SITE PLAN REVIEW DRAWINGS: FOR JONES DAIRY STORAGE FACILITY

1200 JONES DAIRY RD ROLESVILLE, NC 27587

SITE PLAN#: SDP-23-03 REZONING CASE #: MA-22-09 TEXT AMENDMENT CASE #: TA-22-02

S:\33354832\Rolesville_Sewer\DWG\Sheet\C-32-C31_PFS.dwg | Plotted on 11/17/2023 4:08 PM | by Lysiane Barnes

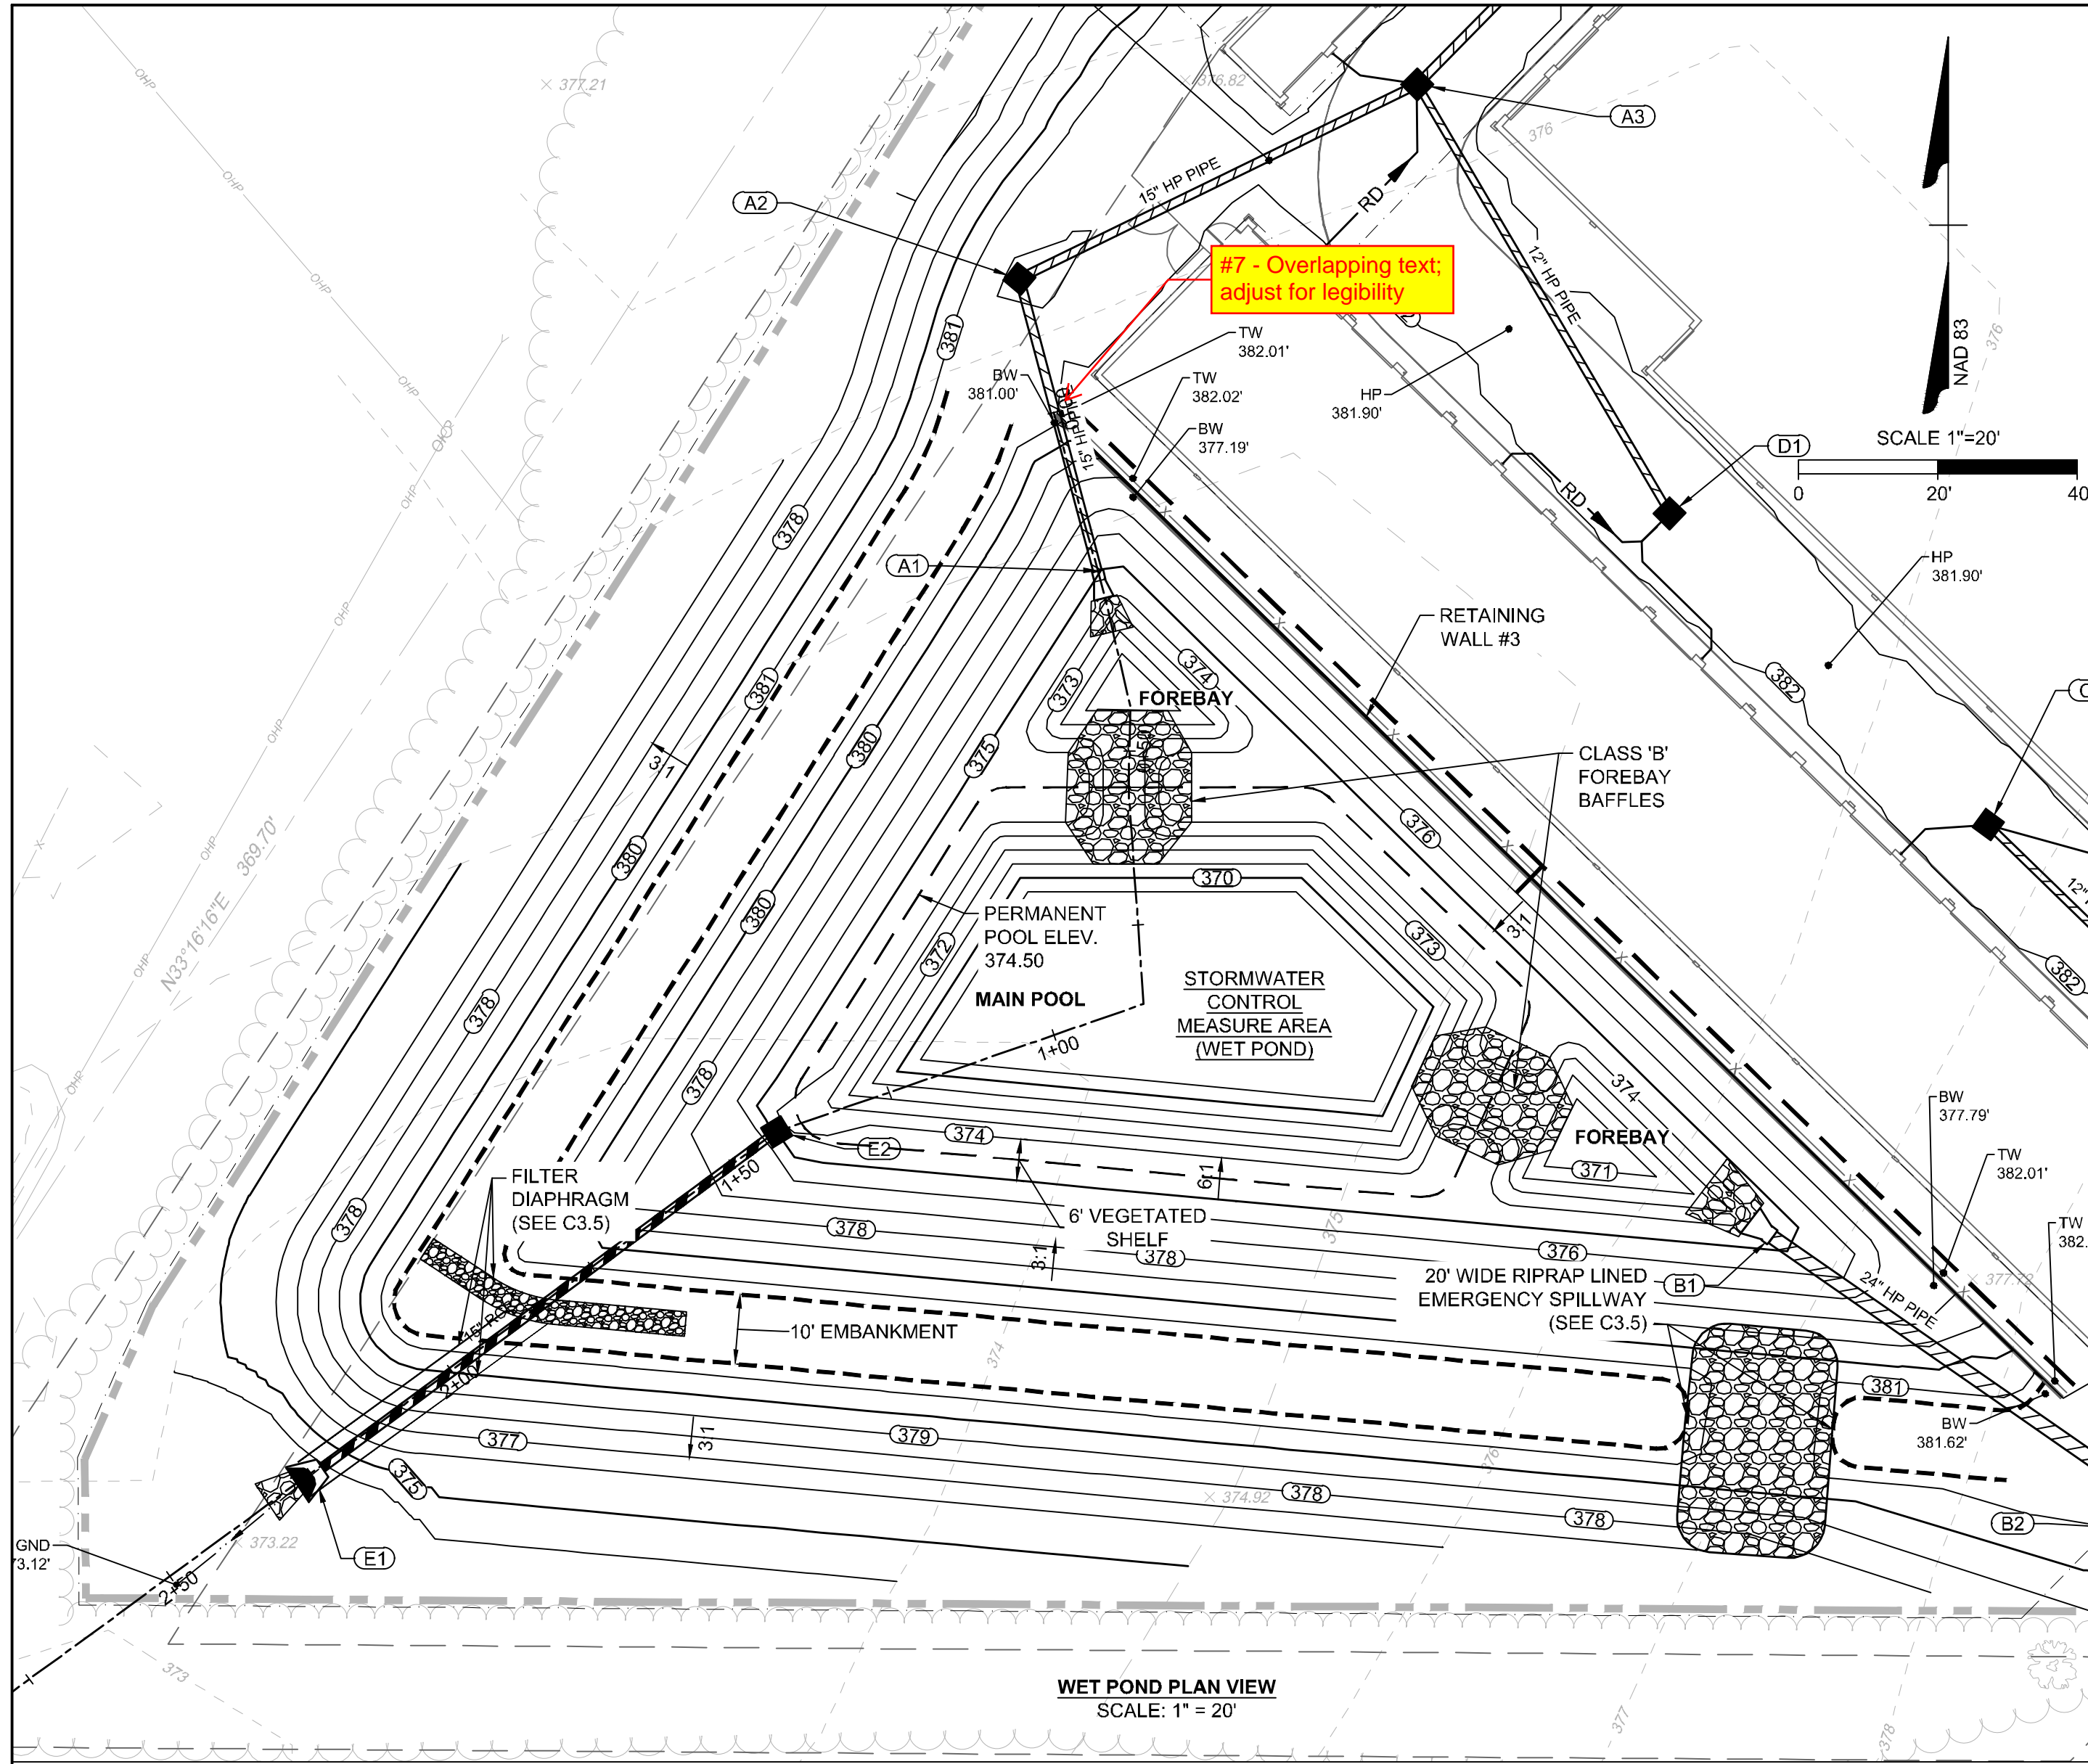
#3 - Doesn't have minimum cover; please revise

#6 - REPEAT: Label separation requirements on ALL profiles

#5 - Sheet number is duplicated

JOB NO.	54832
SHEET NO.	C7.2

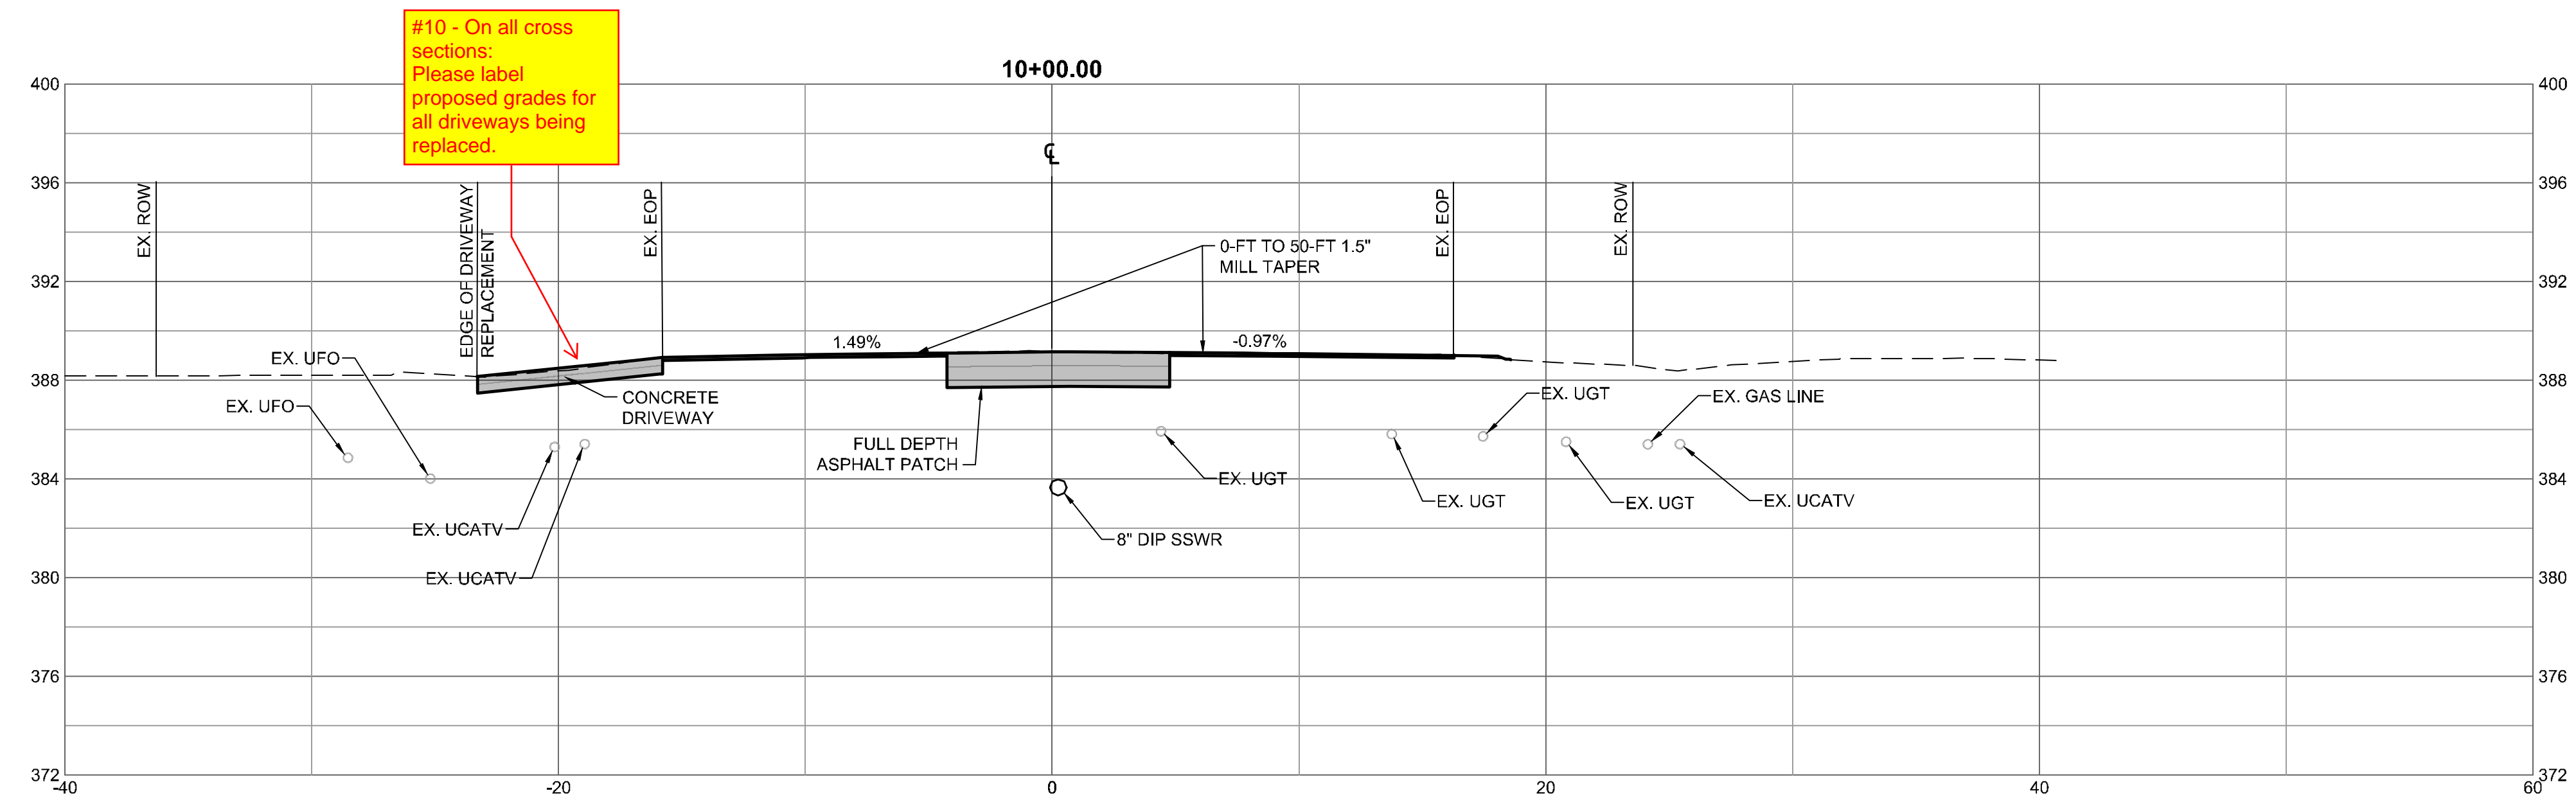
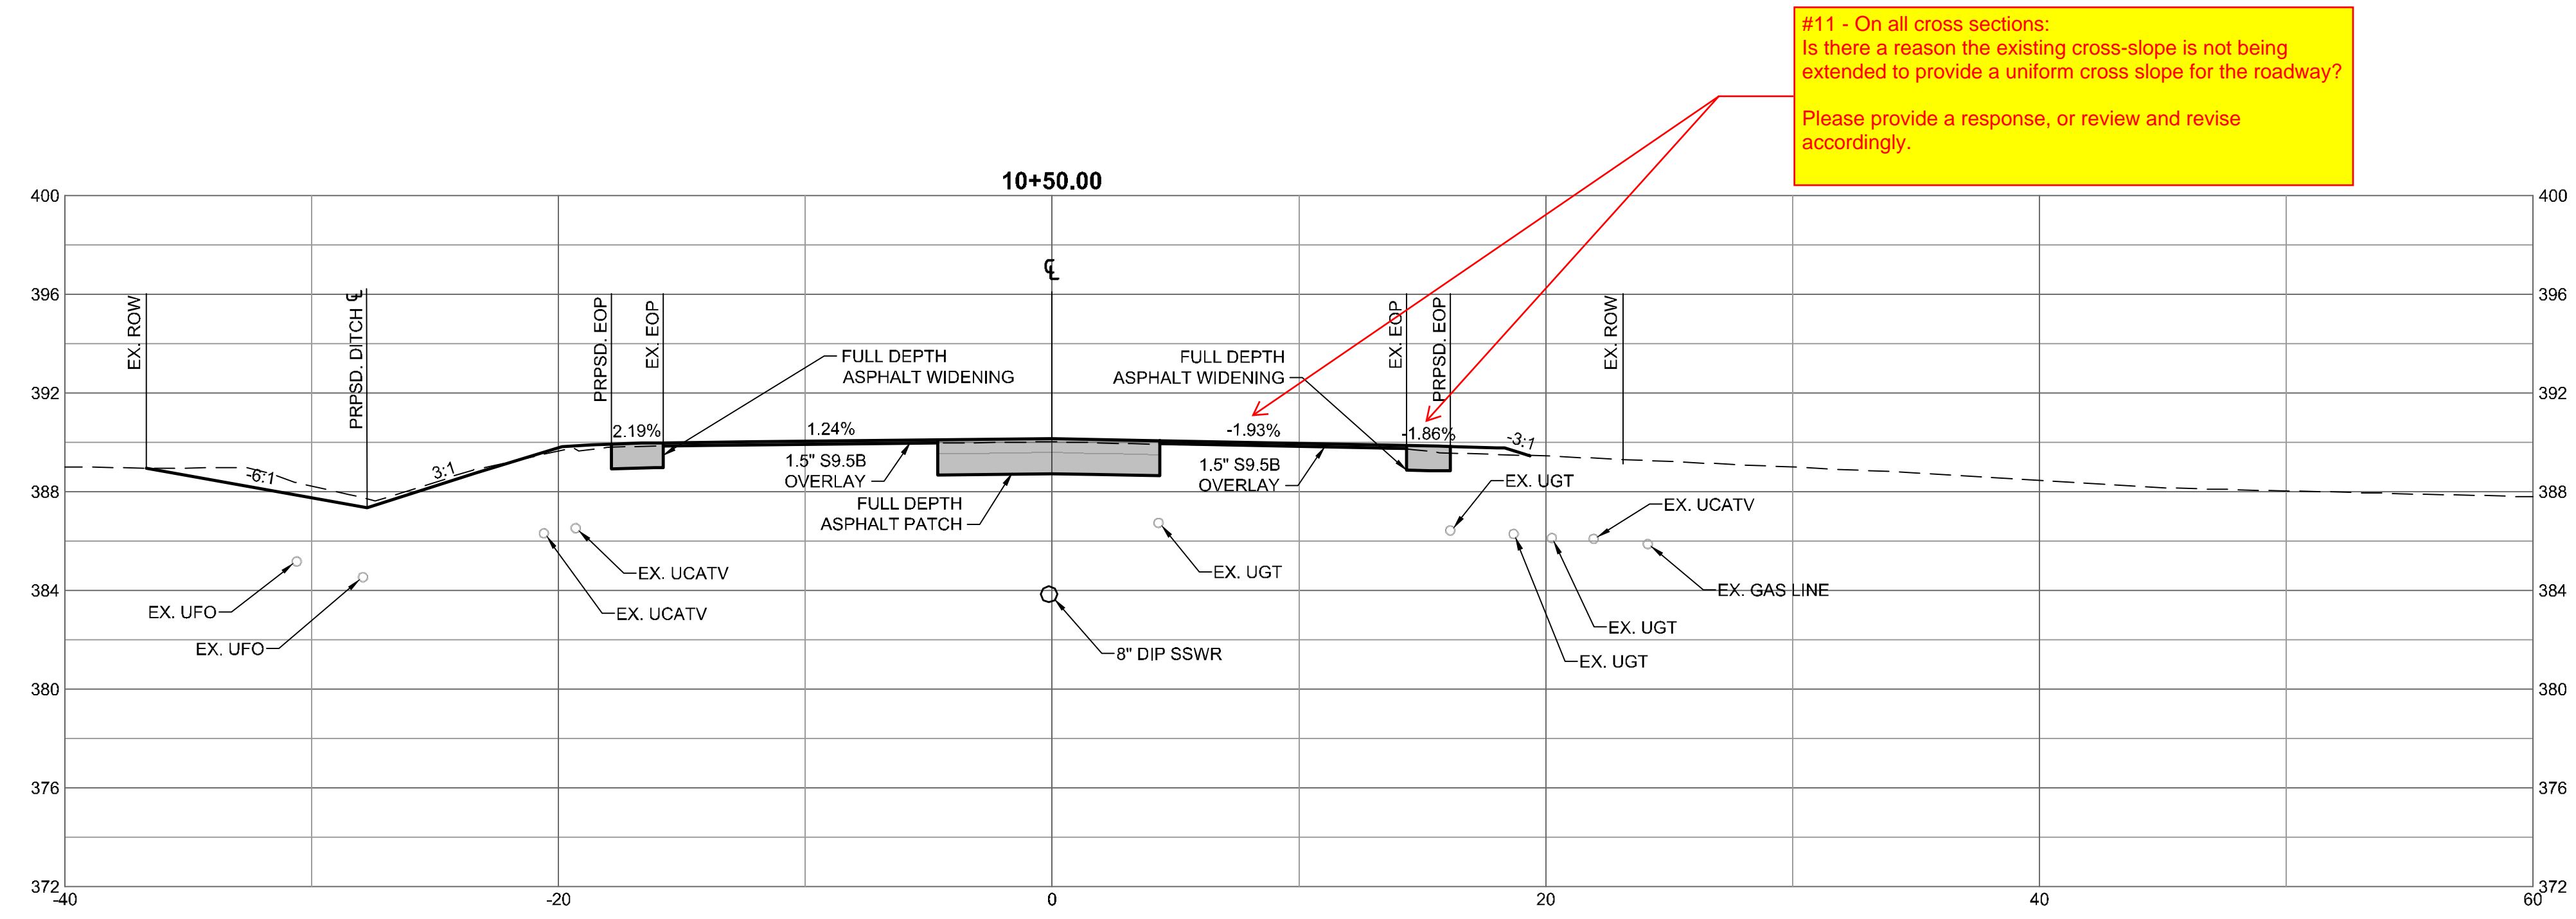
#10 - On all cross sections: Please label proposed grades for all driveways being replaced.

#11 - On all cross sections: Is there a reason the existing cross-slope is not being extended to provide a uniform cross slope for the roadway? Please provide a response, or review and revise accordingly.

SHEET NO.
C7.4

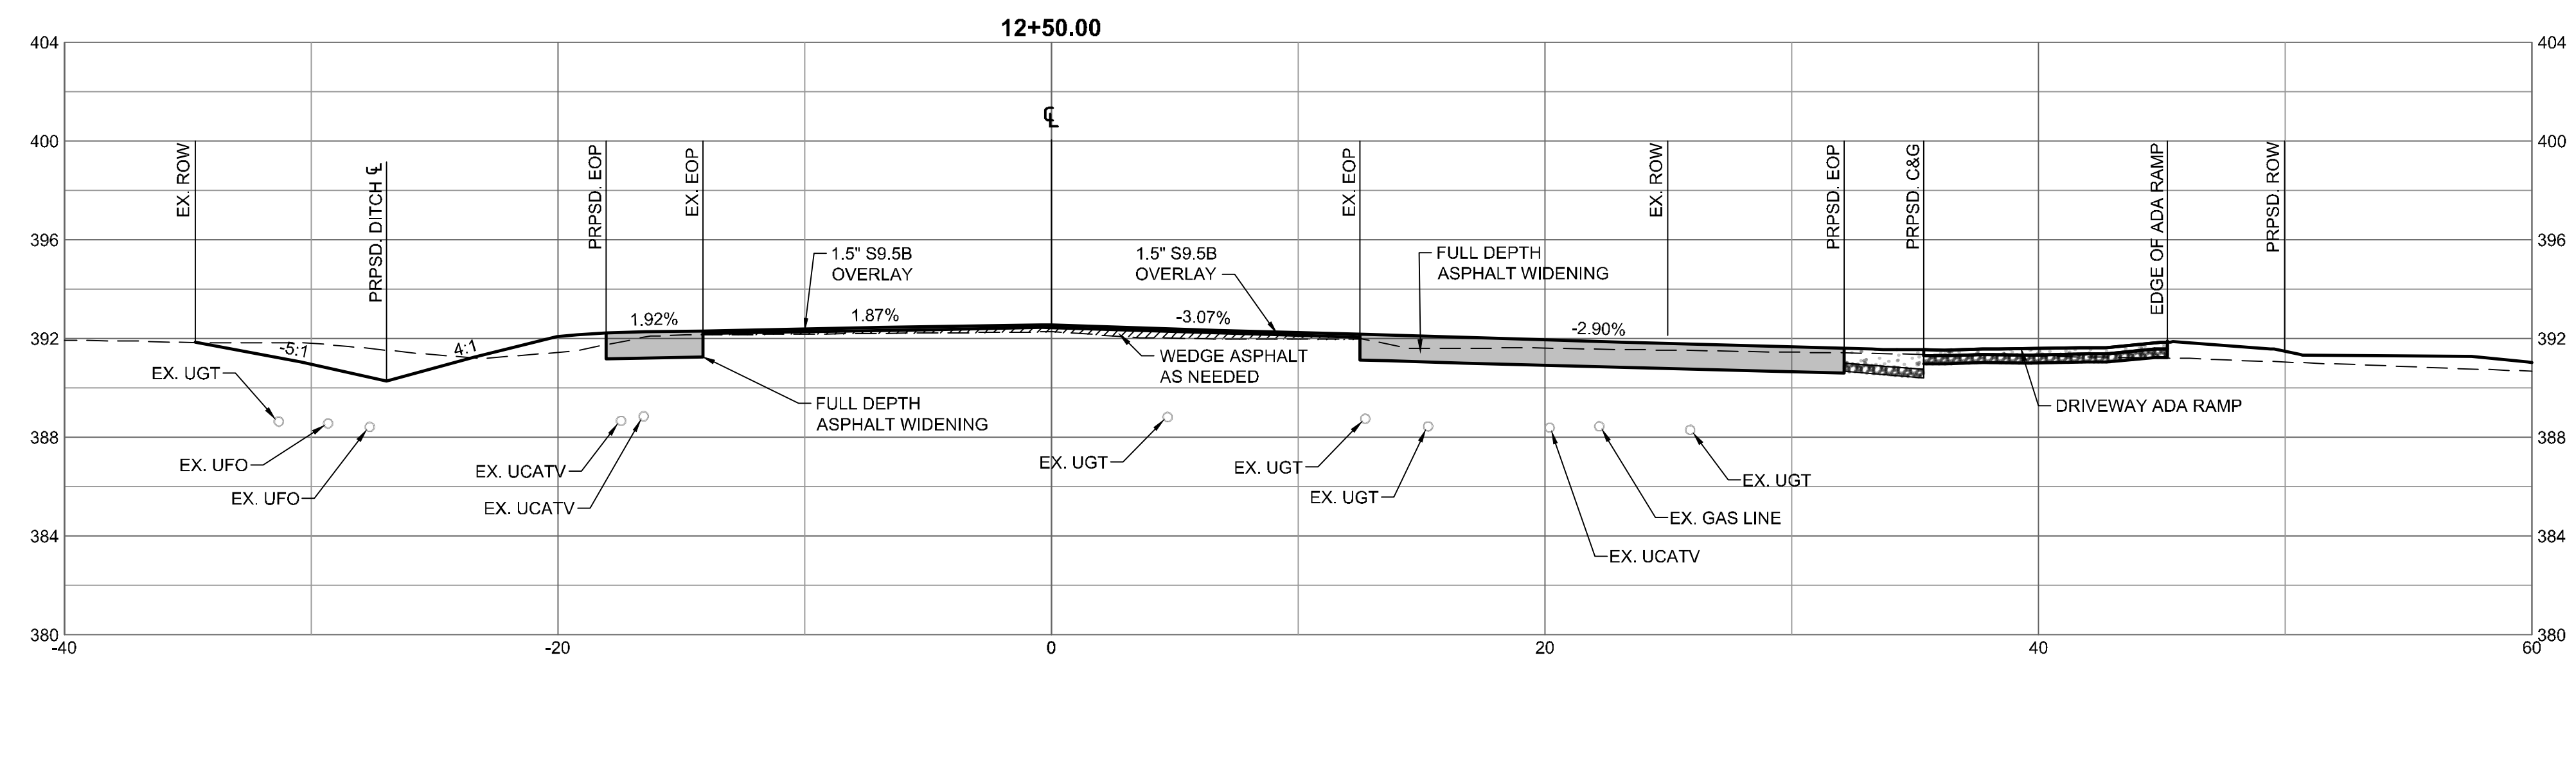
#12 - Provide a label for cover required over culvert; consider minimum cover requirements
